Subject: Transmittal of Revision 1 To Service Bulletin Number
V25000-ENG-72-0321

ENGINE - HP TURBINE ROTOR AND STATOR ASSEMBLY - INTRODUCE NEW FIRST AND SECOND
STAGE TURBINE BLADES WITH UNDER PLATFORM COATING

MODEL APPLICATION

V2500-A1

Location of the Stage 1 High Pressure Turbine Blade
Figure 1

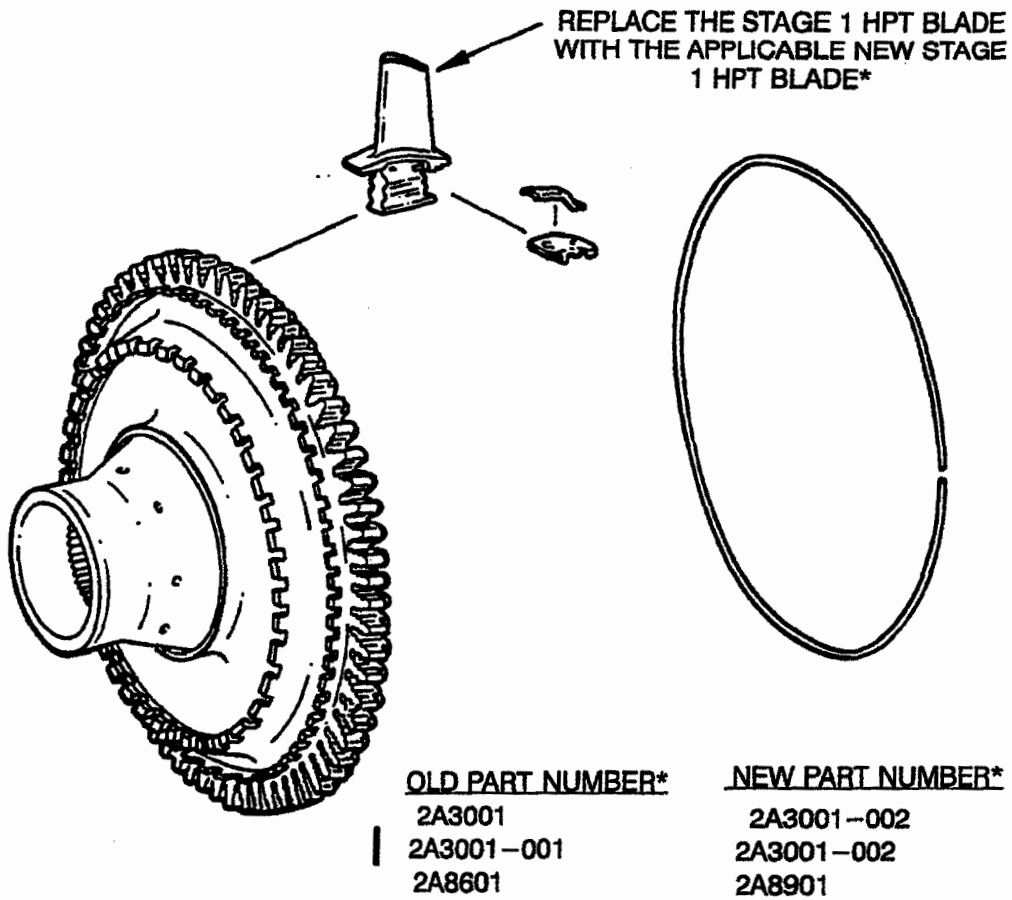
- (1) Do a modification of the Stage 1 High Pressure Turbine Blades 2A3001, 2A3001-001 and 2A8601 (64 off). See Reference (2), Chapter/Section 72-45-14. See Figures 1 and 2.

D. Replace the Stage 1 HPT Blades (64 off) by the approved procedure given in Reference (4), Chapter/Section 72-45-10, Assembly-01 and Figure 1.

Modification of the Stage 1 High Pressure Turbine Blade Assembly
Figure 2 (Sheet 1)

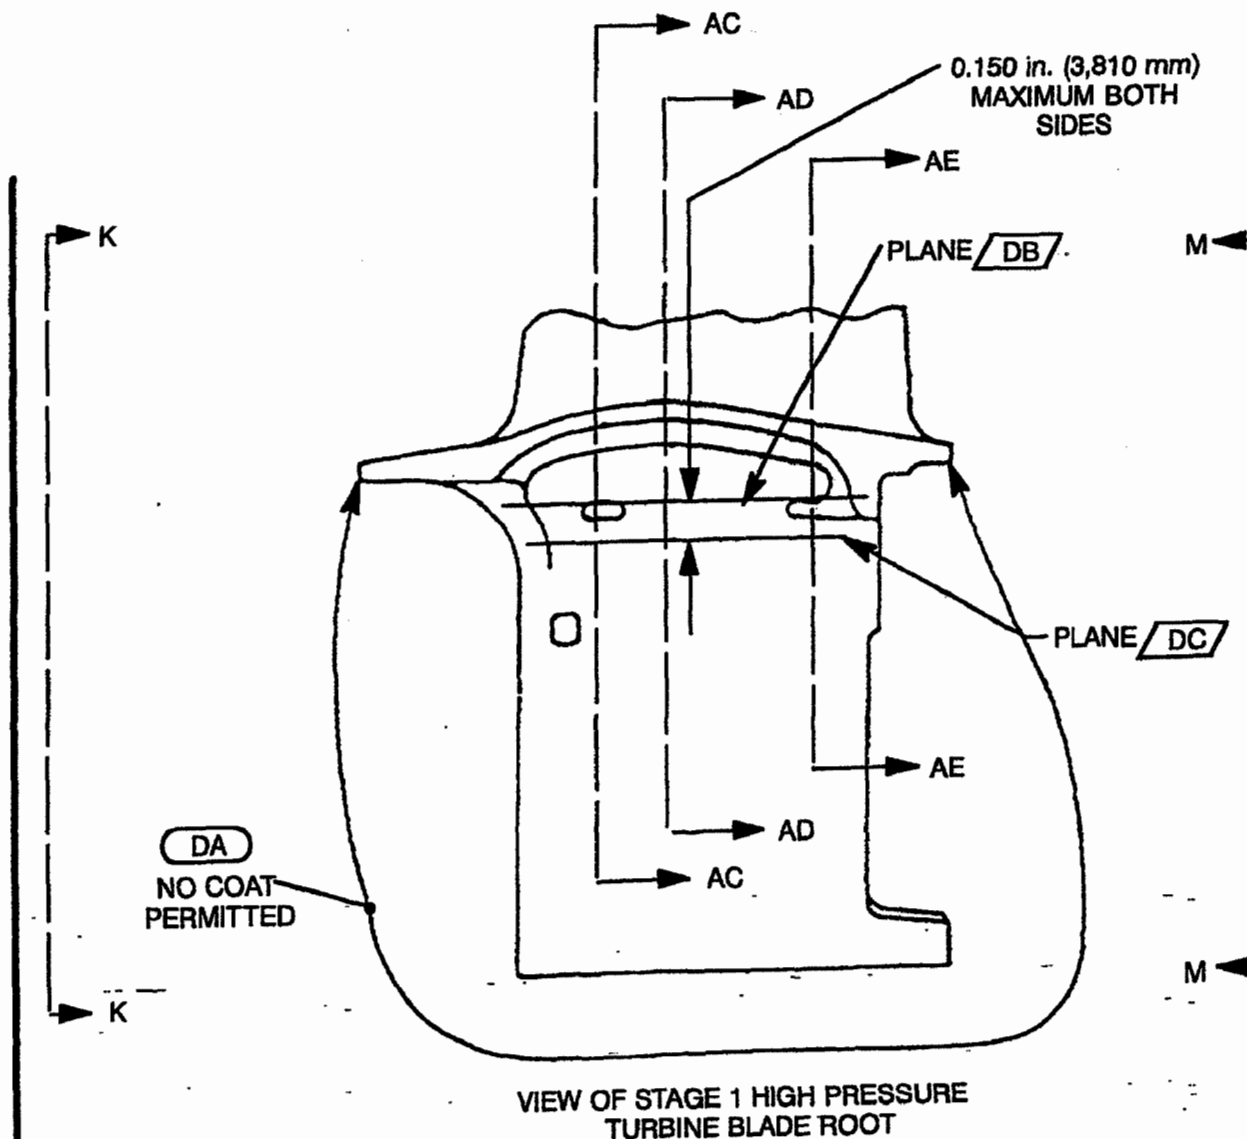
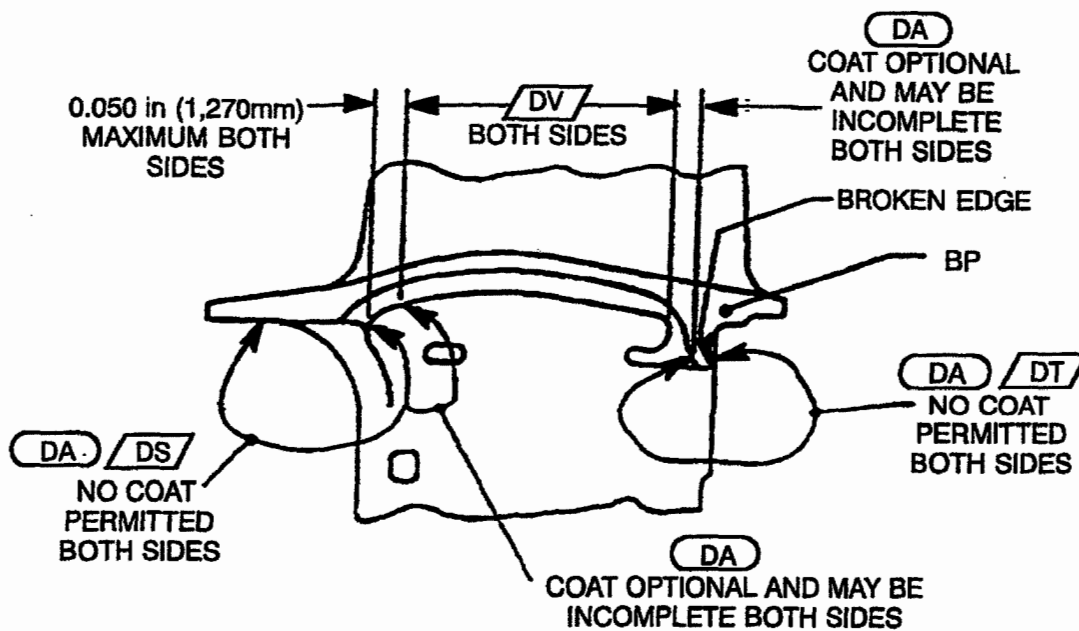
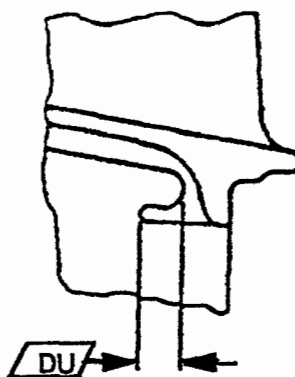
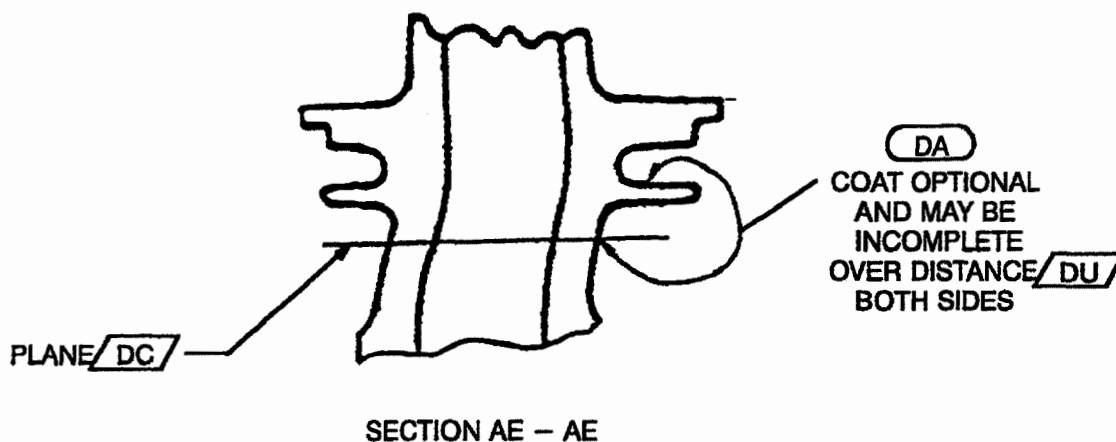
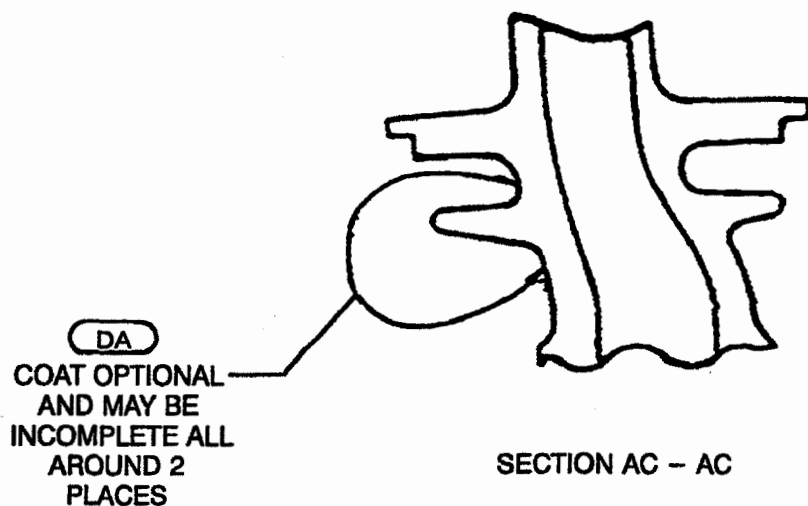
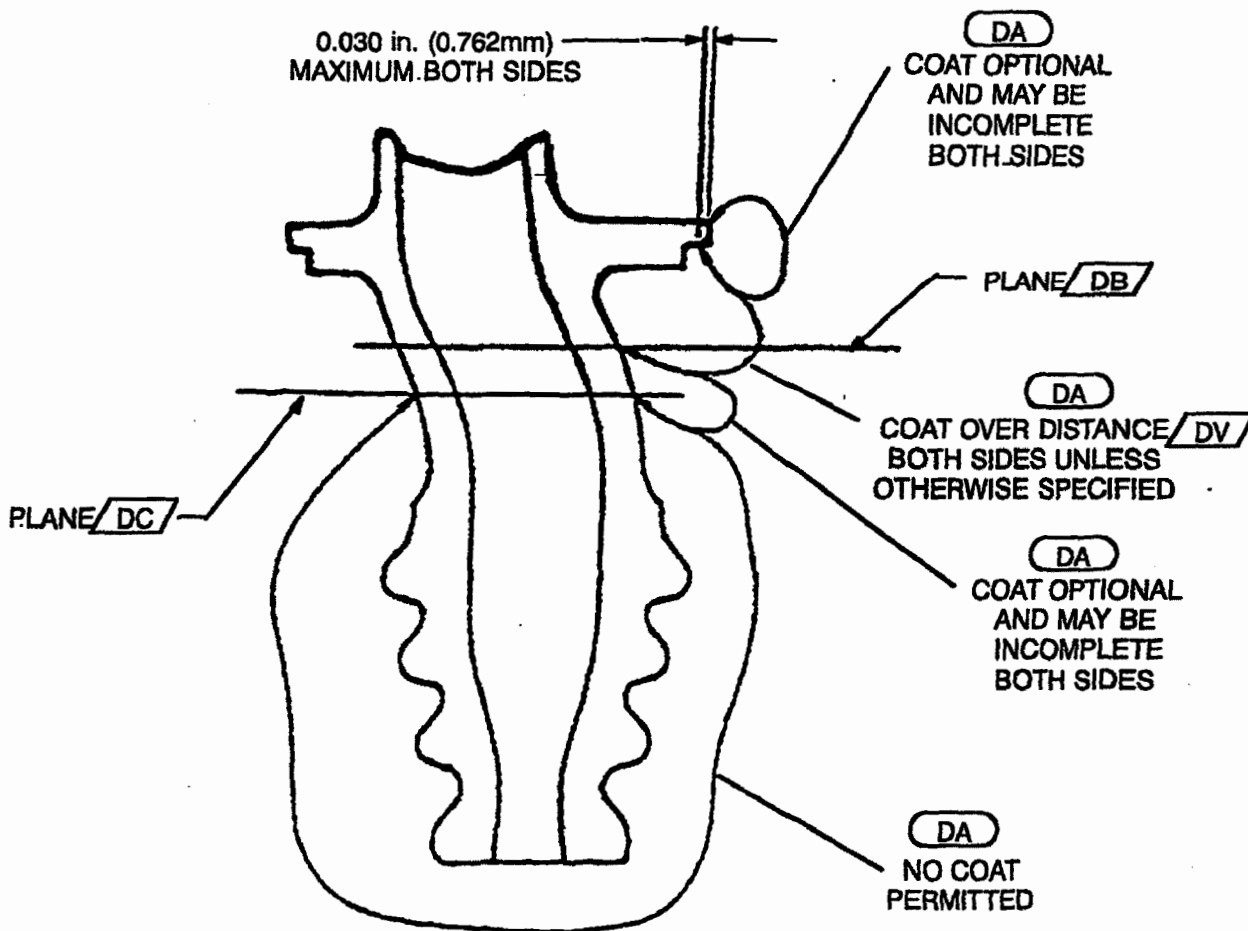
| (f) | Dry abrasive blast the under platform area by the procedure specified. Make sure that the areas which need protection are properly masked (root serrations, root openings and coated areas). | Refer to Reference (3), Chapter/Section 70-12-09, Abrasive Cleaning. See Figure 2. |

- (h) Do a check of the under platform area for the presence of coating by the procedure specified.
- Refer to Reference (3), Chapter/Section 70-28-01, Special Inspection. See Figure 2.
- (i) Touch-up under platform areas that have insufficient coating by the procedure specified.
- Refer to Reference (3), Chapter/Section 70-38-26, Surface Treating. See Figure 2.
- (j) Diffusion heat treat for 1 to 4 hours at 1950 - 2000° F (1065.6 - 1093.6° C) in a dry argon atmosphere.
- Refer to Reference (3), Chapter/Section 70-37-03, Heat Treating. See Figure 2.
- 1 The cooling rate must be 10° F/minutes minimum average to 1200° F (648.9° C) and cooling at any convenient rate thereafter.

Refer to Reference (3), Chapter/Section 70-37-03, Heat Treating. See Figure 2.

DA COAT IN THE APPLICABLE AREA BY THE PROCEDURE SPECIFIED IN THE TEXT

Location of the Stage 2 High Pressure Turbine Blade Assembly
Figure 3

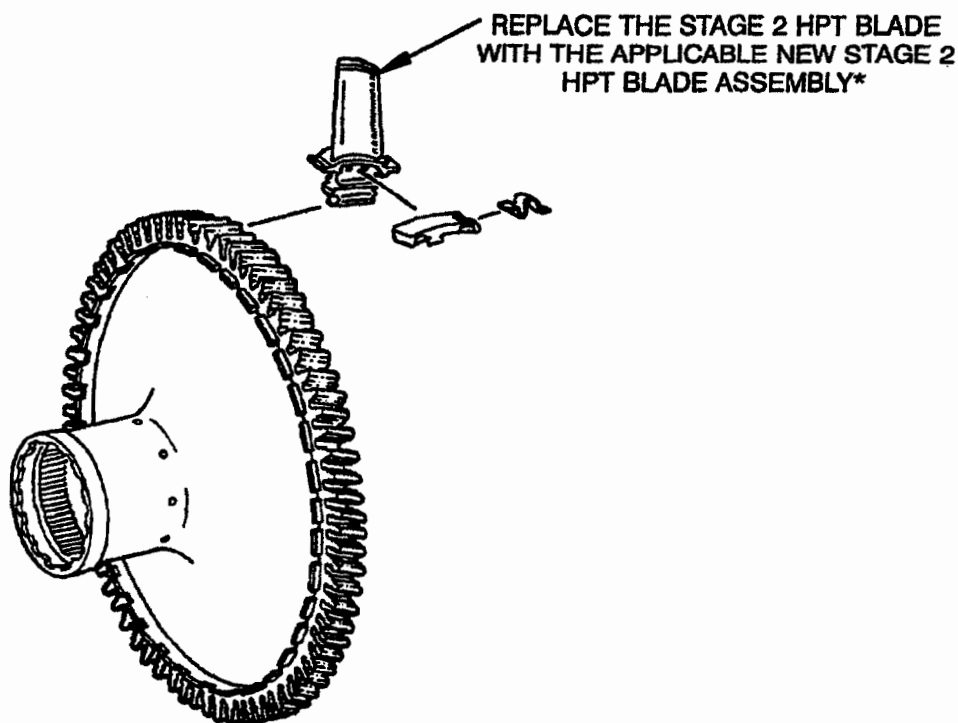
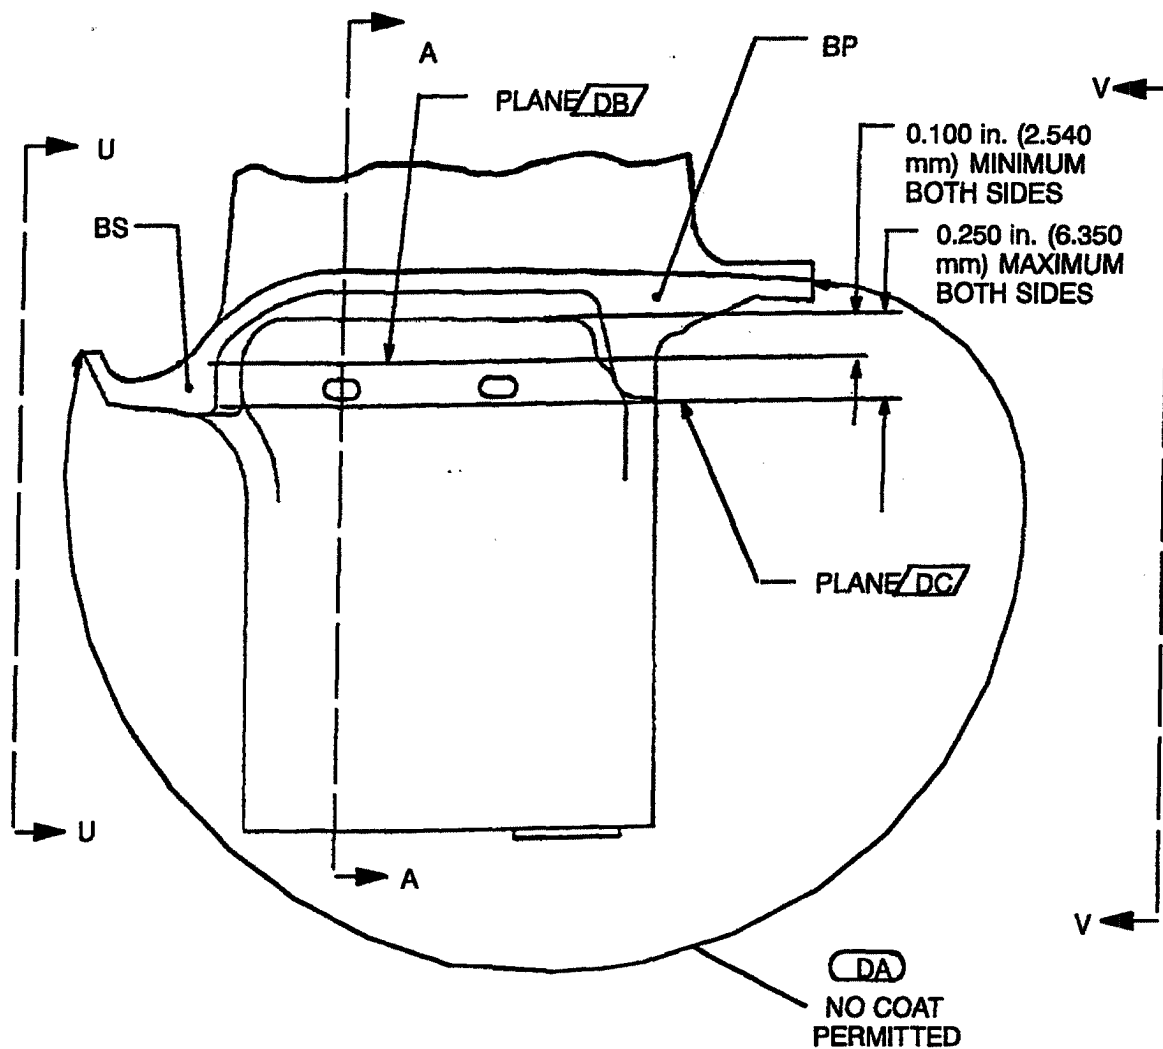
- (1) Do a modification of the Stage 2 High Pressure Turbine Blades 2A1102, 2A1102-001 and 2A8602 (72 off). See Reference (2), Chapter/Section 72-45-32 for the applicable engine model. See Figures 3 and 4.

E. Replace the Stage 2 HPT Blades (72 off) by the approved procedure given in Reference (4), Chapter/Section 72-45-30, Assembly-01 and Figure 3.

OLD PART NUMBER*

2A1102
2A1102-001
2A8602

NEW PART NUMBER*

2A1102-002
2A1102-002
2A8902
